Question

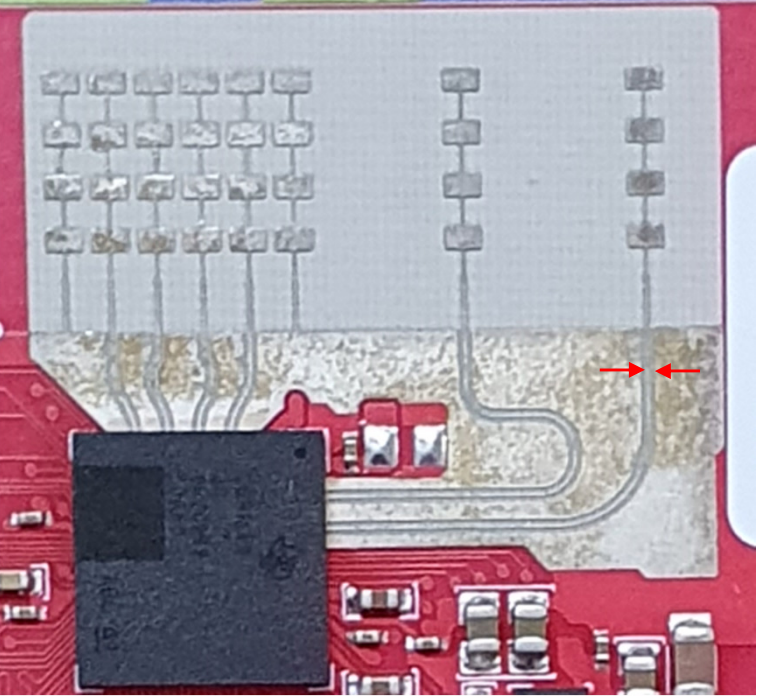
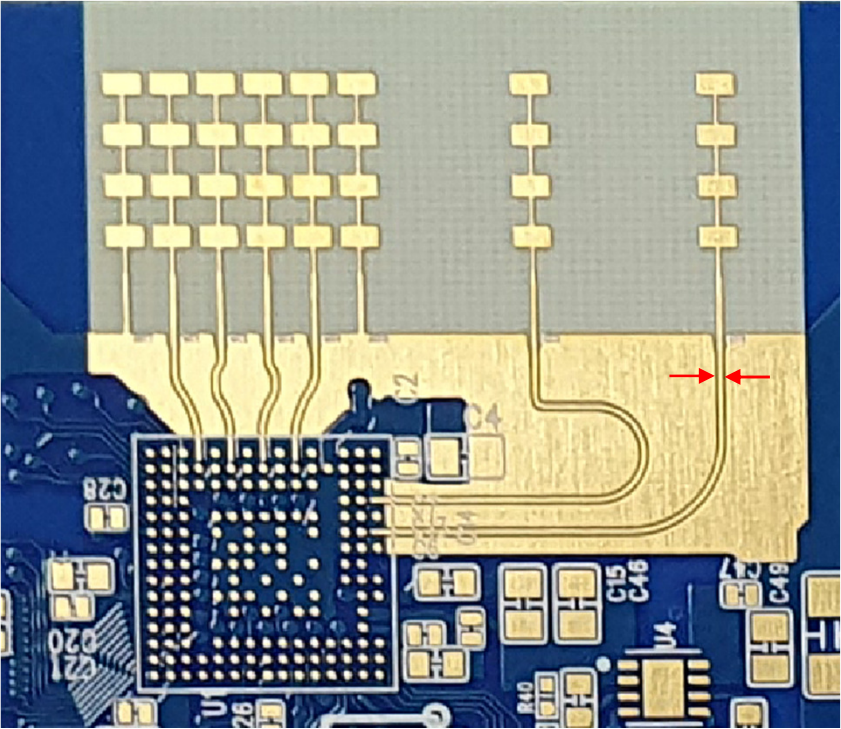
If the gap between the wiring reaching the TX(RX) antenna and the surrounding ground is close, can performance degrade?
